Modifications to DTC Standards
Hyatt Regency – Nashville Yards Parcel 1
19 – O’Connell
Ragan-Smith Associates, Inc., applicant; Uptown Property Holdings, LLC, owner

Downtown Code DRC Meeting of 3/01/2018

2017DTC-027-001 Minutes from 12/7/2017 DTC DRC Meeting

Revised Facades areas

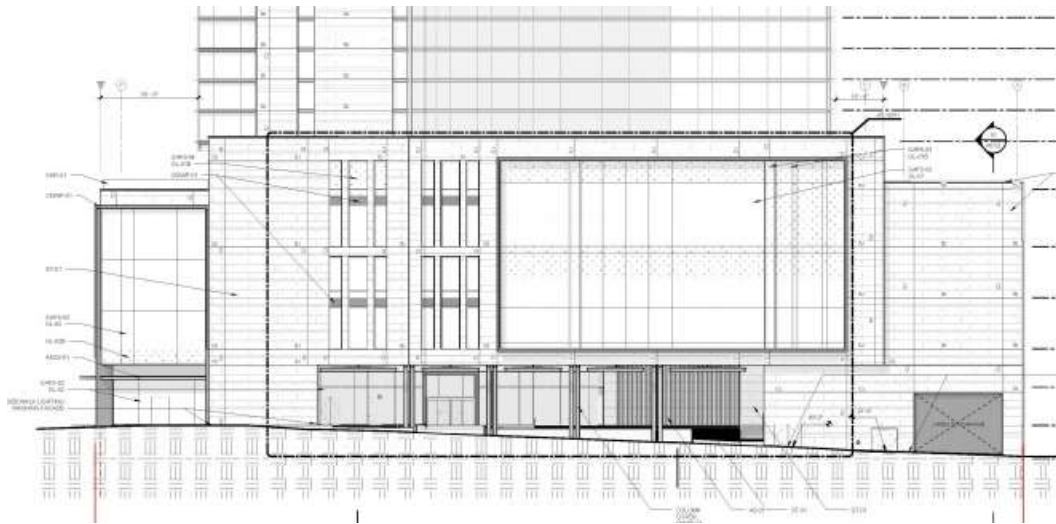
The project is returning with a revised ground level facade design along 10th Avenue North, per the DRC’s conditional approval received on 12/7/2017. The project is proposing an aluminum panel system, and seat wall areas to articulate the ground level portion of 10th Avenue frontage. Previously these facades areas consisted of a flat plane treatment.

Staff recommends approval. The revised ground floor facade adds additional interest and articulation to the pedestrian realm along the 10th Avenue North.
